STARBUCKS SITE IMPROVEMENTS

ROBERT B. AIKENS AND ASSOCIATES
 350 N. OLD WOODWARD
 SUITE 300
 BIRMINGHAM, MI 48009
 TELE: 248-283-2387
 CONTACT: JAMES FIELDER
 EMAIL: fielder@rbaikens.com

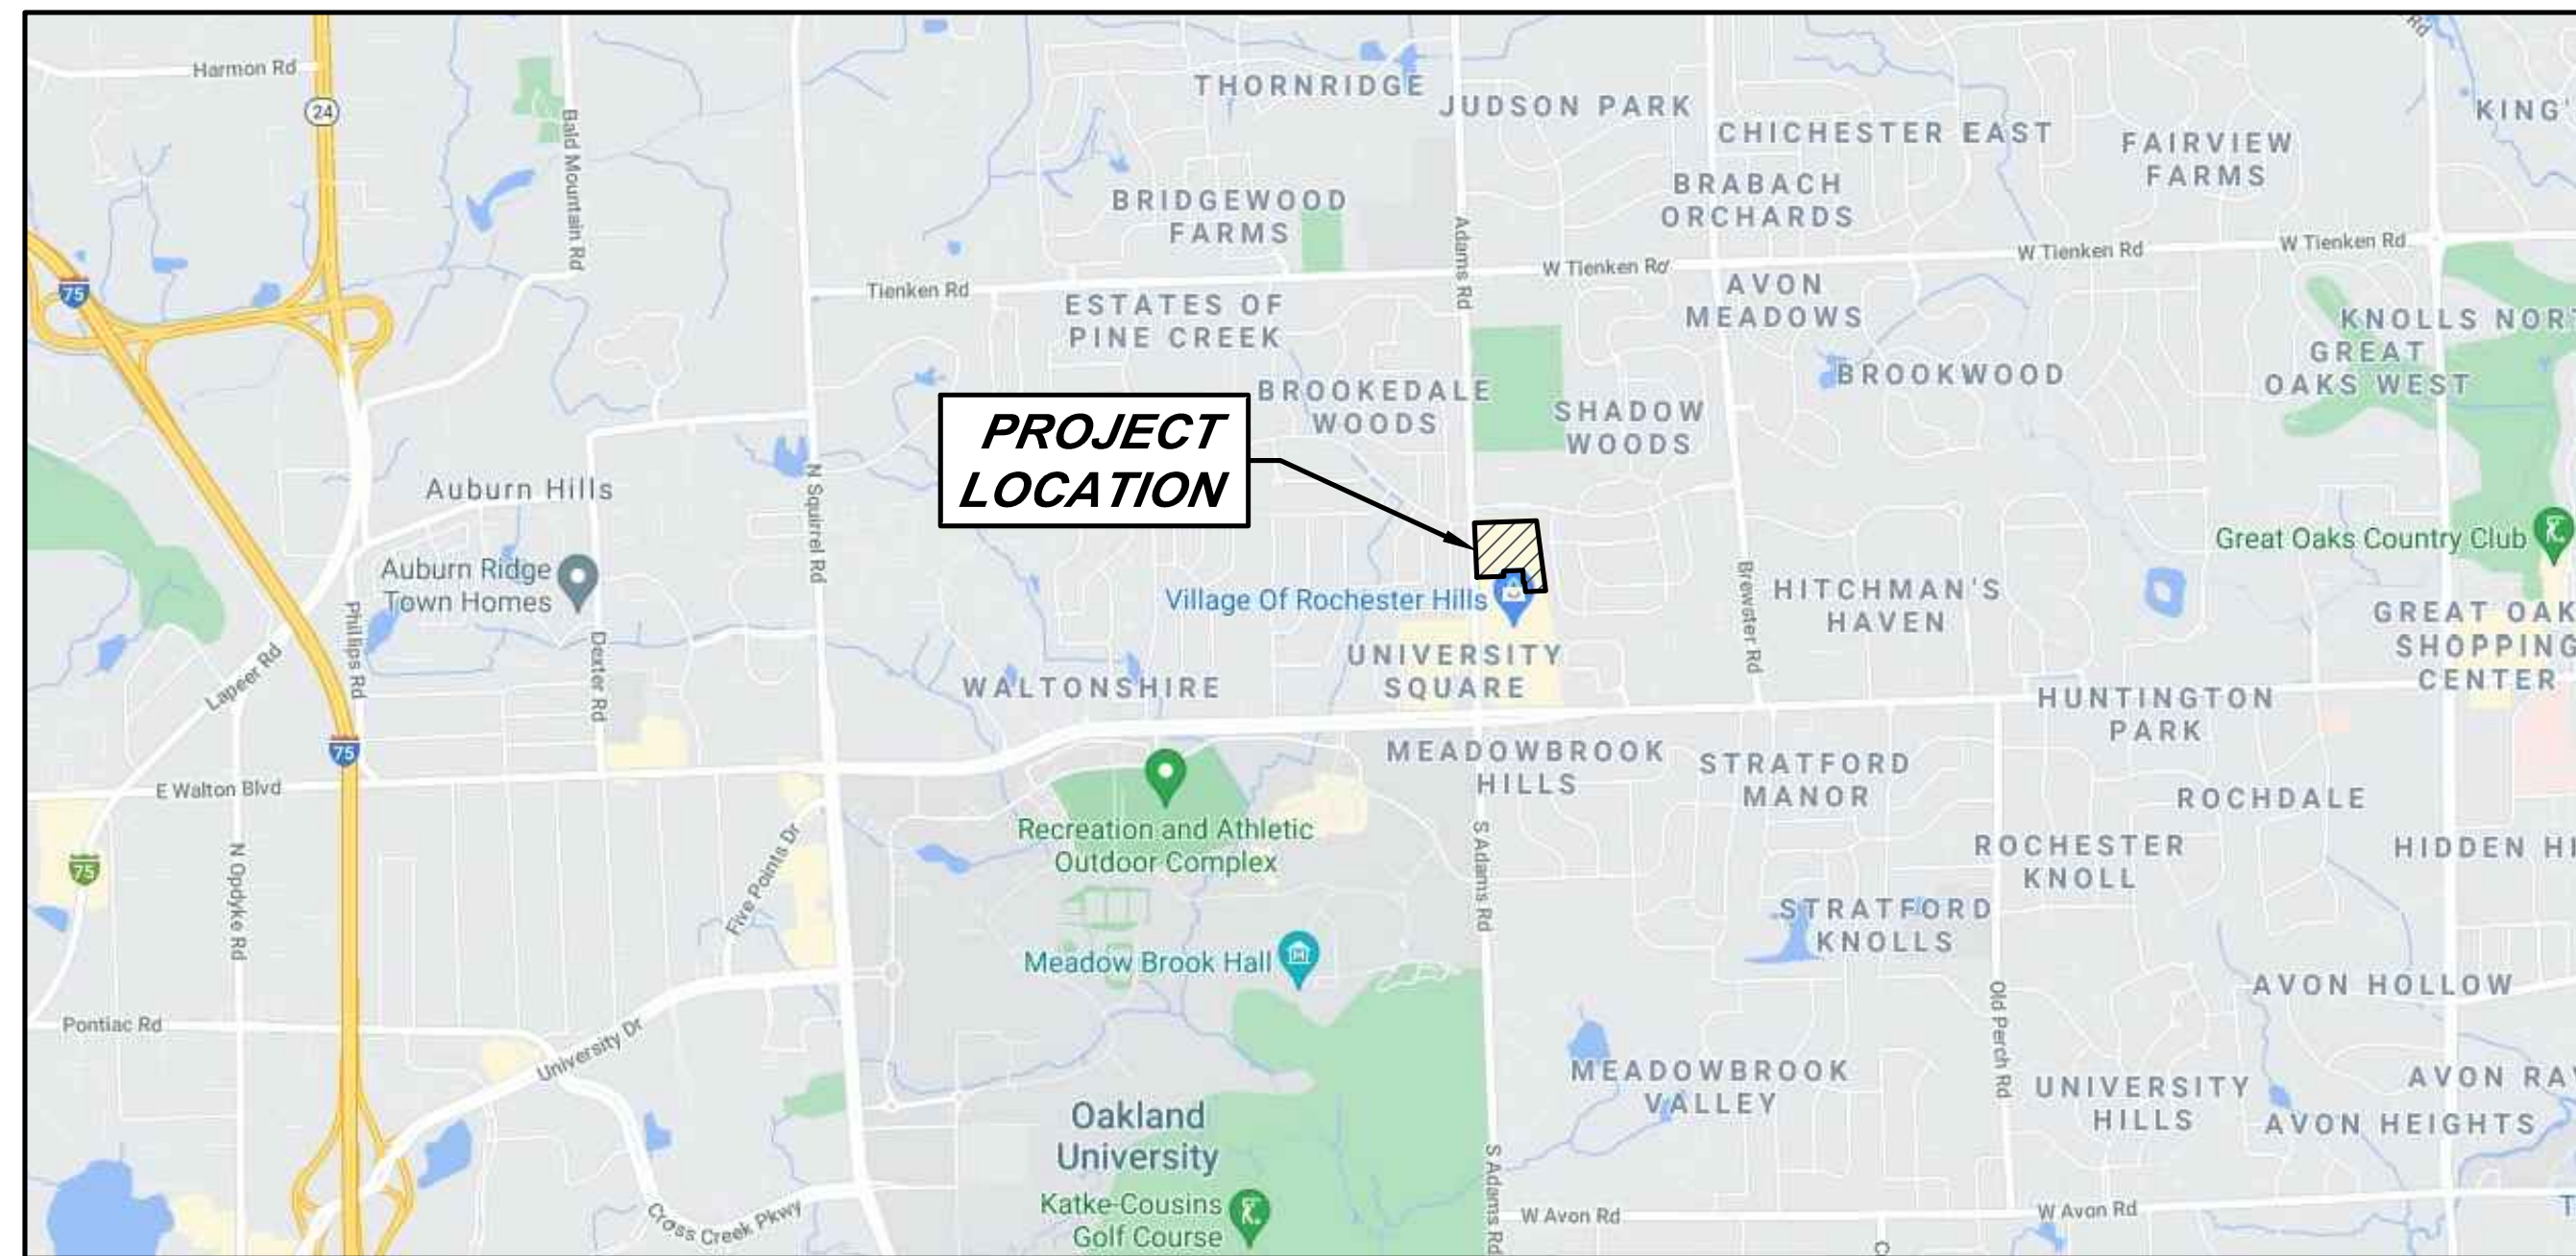
Site Plan Review		
Reviewed for compliance to the City Ordinance, Building and Fire Codes		
Department	Reviewer	Approved
Planning	Kristen Kapelanski 248-841-2772 KapelanskiK@RochesterHills.org	Yes
Building	Mark Artinian 248-841-2446 ArtinianM@RochesterHills.org	Yes w/ conditions
Engineering	Jason Boughton 248-841-2490 BoughtonJ@RochesterHills.org	Yes
Traffic	Keith Depp 248-841-2503 DeppK@RochesterHills.org	Yes w/ conditions
Nat. Resources	Gerry Pink 248-841-2550 PinkG@RochesterHills.org	Yes
Fire	Lt. Josh Boyce 248-841-2713 BoyceJ@RochesterHills.org	Yes
<p align="center">City of Rochester Hills Planning & Economic Development</p> <p align="center">Conditions and mark-ups noted throughout the plan set must be addressed prior to final approval.</p>

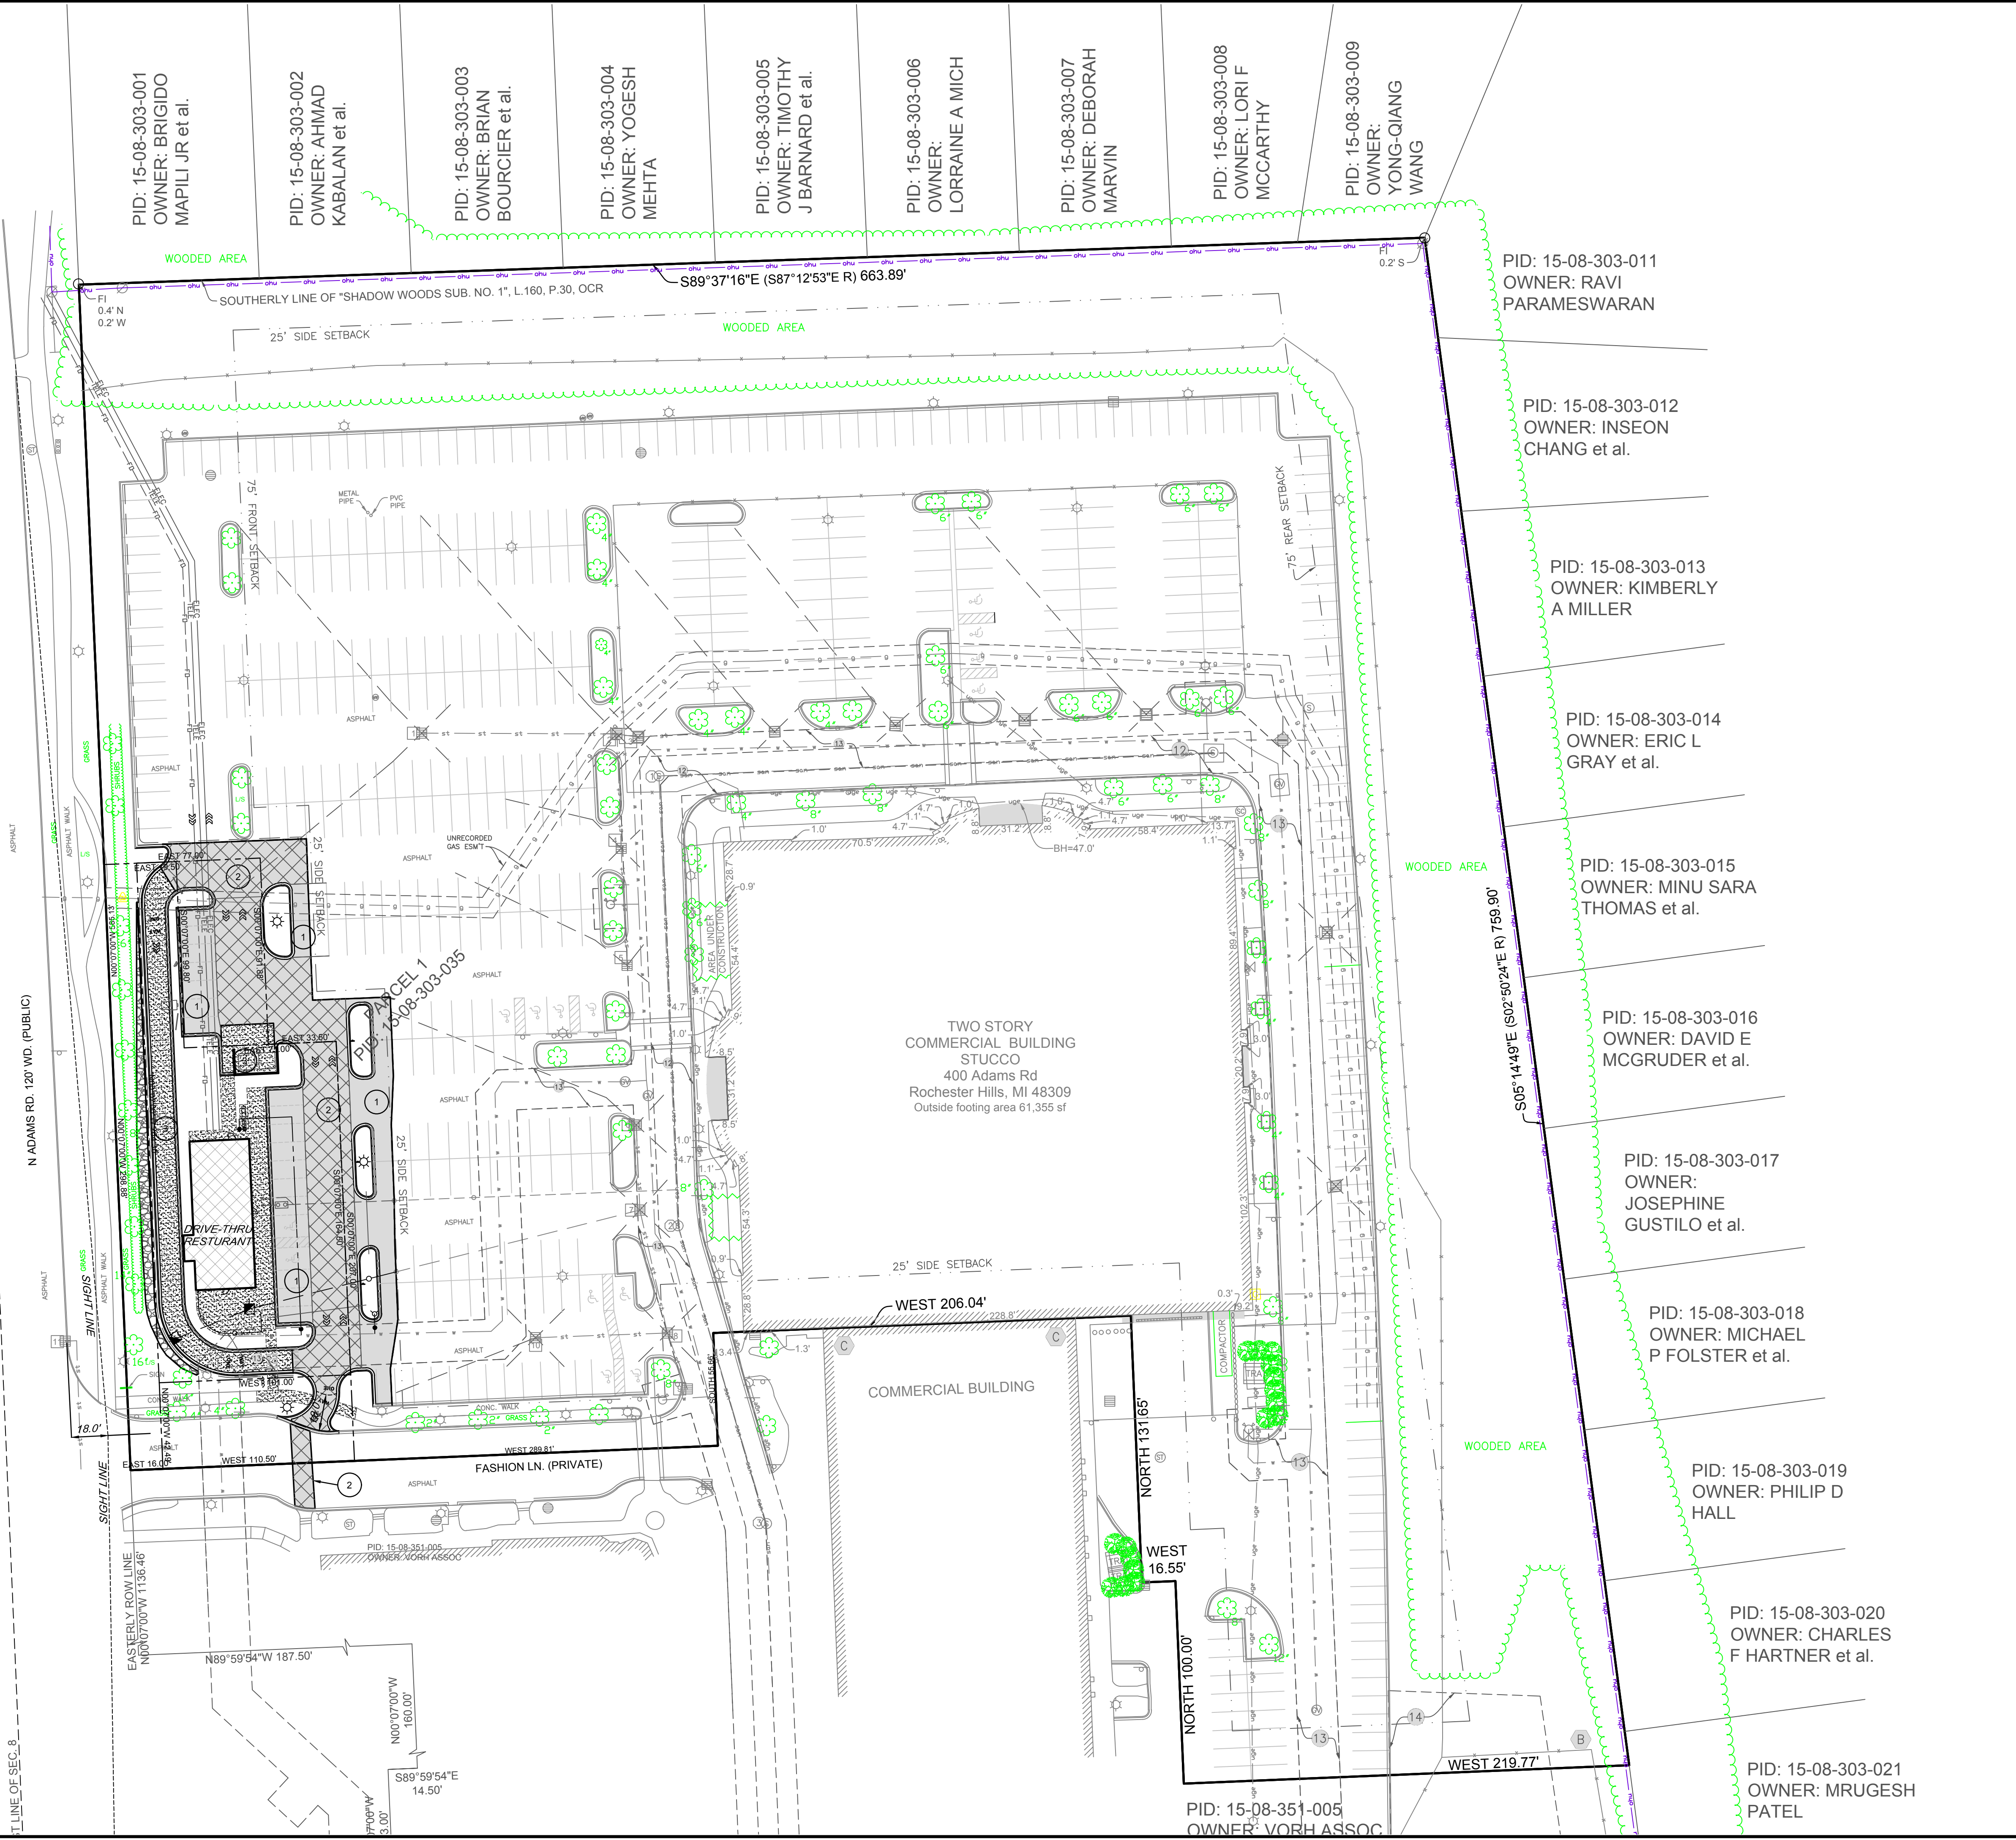
CAR BY	MARK	REVISED PER CITY REVIEW COMMENTS	2-3-22
REVISIONS			DATE
<p>THE WORK REPRESENTED BY THIS DRAWING WAS DESIGNED BY THE ENGINEER FOR THIS SPECIFIC APPLICATION AND SPECIFIC LOCATION DESCRIBED HEREIN IN ACCORDANCE WITH THE CONDITIONS PREVALENT AT THE TIME THE DESIGN WAS DONE. THE ENGINEER DOES NOT GUARANTEE AND WILL NOT BE LIABLE FOR ANY OTHER LOCATION, CONDITION, DESIGN OR PURPOSE.</p>			
<p>ROBERT B. AIKENS AND ASSOCIATES 350 N. OLD WOODWARD, SUITE 300 BIRMINGHAM, MI 48009</p>			
<p>PAVING PLAN SITE IMPROVEMENTS STARBUCKS CITY OF ROCHESTER HILLS</p>			
		<p>SAGINAW OFFICE 230 S. Washington Ave. Saginaw, MI 48607 Tel. 989-754-4717 Fax. 989-754-4440 www.SpicerGroup.com</p>	
DE. BY:	CAR	CH. BY:	BMR
DR. BY:	CAR	APP. BY:	DSP
PROJECT NO.		130328SG2021	
STDS.	SHEET 4 OF 12	C	
DATE	DECEMBER, 2021	FILE NO.	D-5828-4
SCALE	1" = 40'	4
